Product Change Notification (PCN)

PCN Number	507348	Date Issued	July 01, 2019
Reason for Change	Change to Product		
Change Type Description	This letter is to inform you that changes are being made to the part(s) identified in this Notice. The change may affect the fit, form, function or appearance of the parts, or it may result in a change to the specification. The pictures below show an example of the possible differences.		
Assessment of Change	Product will be fully qualified before it is shipped. Qualification reports will be available after below listed date		
Internal Molex Qualification Date	July 25, 2019		
Sample Availability Date (Changed Part)	July 25, 2019		
Planned Implementation Date	December 31, 2019		
Method of Identifying Change	Date code

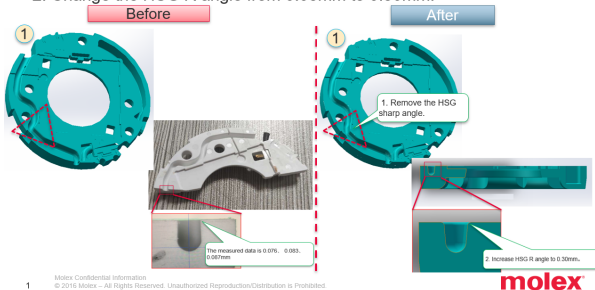
- 1. Remove the HSG sharp angle;
- 2. Change the HSG R angle from 0.08mm to 0.30mm.

- For the SSL part number 1805550056, we found the following problems, the HSG slot of the product has no guide rounded corner and sharp bend angle according to the groove. It is difficult to press in smoothly when pressing the line, which results in great damage to the operator's finger (Fig. 1 and 2), thus affecting the production efficiency. In addition, the sharp corners of the products sometimes scratch the cables, resulting in bad products (Fig. 3, 4). Therefore, we apply for adjusting the wire groove.
